RESOLUTION NO. 24-128

A RESOLUTION OF THE CITY OF PANAMA CITY BEACH, FLORIDA, APPROVING CHANGE ORDER #10 TO THE CITY'S AGREEMENT WITH CWR CONTRACTING, INC. FOR CONSTRUCTION OF FRONT BEACH ROAD SEGMENT 3 IN THE AMOUNT OF \$115,547.80.

CHANGE ORDER

CITY OF PANAMA CITY BEACH AGENDA ITEM SUMMARY

S000

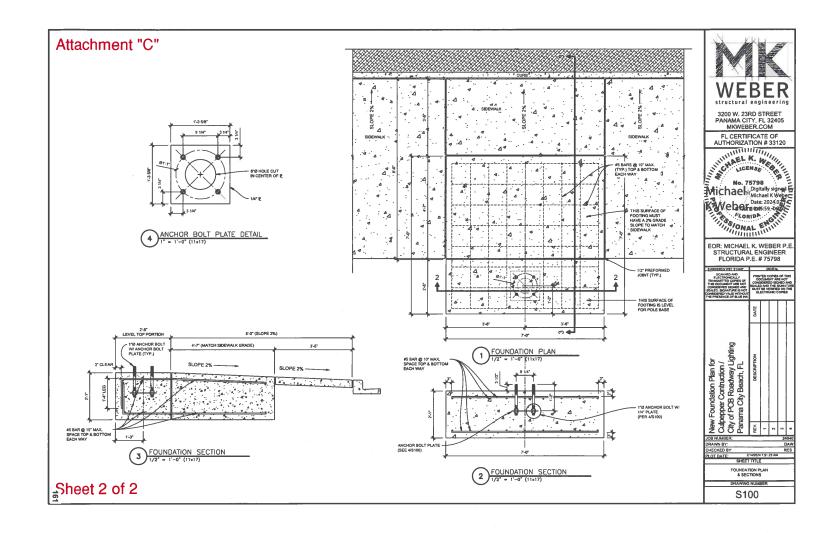
2.)	where standard foundations c \$8000.00 per foundation and item based on Engineer's Esti locations designated by the E	for installation of conflict foundate annot be installed due to utility or estimated quantity of 8 EA total I imate. Install foundations per atta agineer and reflected on final as- indations at \$ 8000.00 per EA = \$	onflicts. A contract unit price of locations is established in this pay sched design (Attachment "C") at built drawings.
Reason for Change Order:	to underground service along	nd landscape irrigation pumps int	o service ahead of the conversion of FPL p each Road west of the new roundabout d existing utilities.
Special Notice:	heen verified to be within the Cit	u of Danama City Reach Construc	ction Design Standards and Specifications
	es satisfaction of all compensation
